Docket Number:	24-BUSMTG-01
Project Title:	2024 Business Meeting Agendas, Transcripts, Minutes, and Public Comments
TN #:	254465
Document Title:	San Diego Gas & Electric Comments on the 2023-2040 California Energy Demand Forecast
Description:	N/A
Filer:	System
Organization:	San Diego Gas & Electric (SDG&E)
Submitter Role:	Public
Submission Date:	2/14/2024 4:42:49 PM
Docketed Date:	2/14/2024

SDG&E Comments on the 2023-2040 California Energy Demand Forecast

**SUBJECT: San Diego Gas & Electric Company (SDG&E) Comments on
2023-2040 California Energy Demand Forecast**

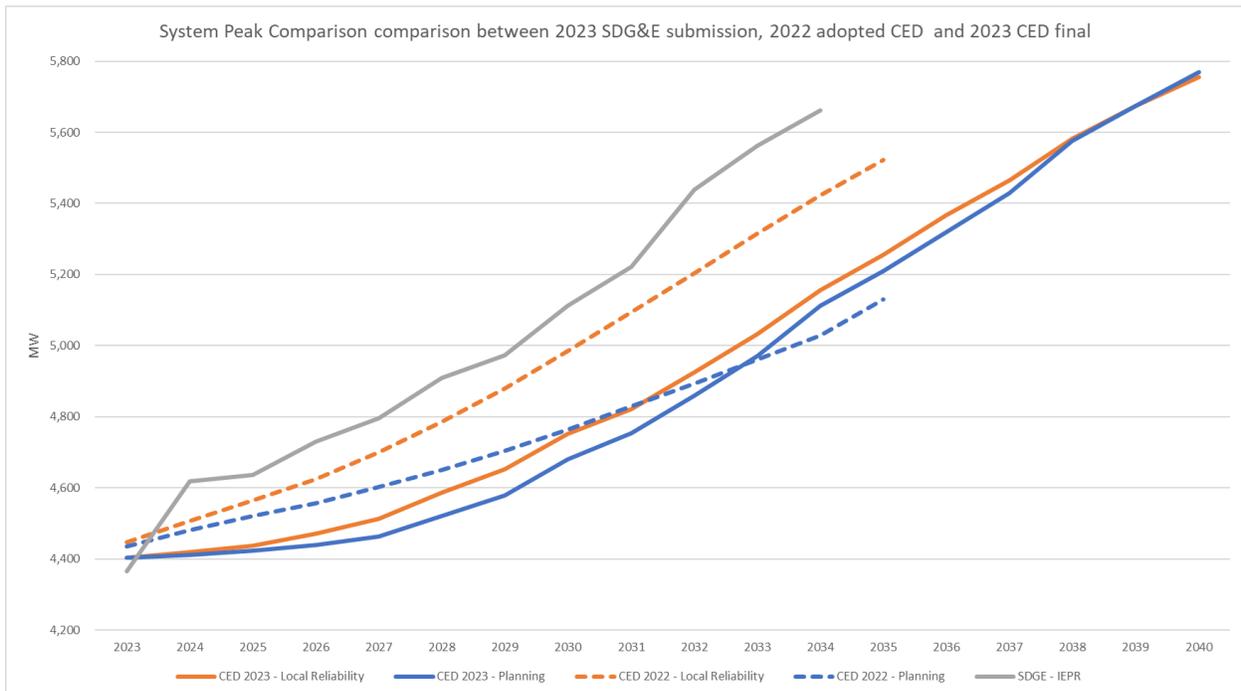
The disparity between SDG&E’s submitted 2023 forecast and the CEC’s 2023 CED Forecast varies on a year-to-year basis, but reaches up to approximately 500 megawatts of system peak demand in the later years, as shown in the chart below.¹ This is equivalent to up to 10% of SDG&E’s peak load.

SDG&E highlights this disparity to underscore the need for continued evaluation and discussion with stakeholders to ensure that the forecast is well understood and does not unintentionally impact our collective ability to equitably achieve state climate and clean energy goals.
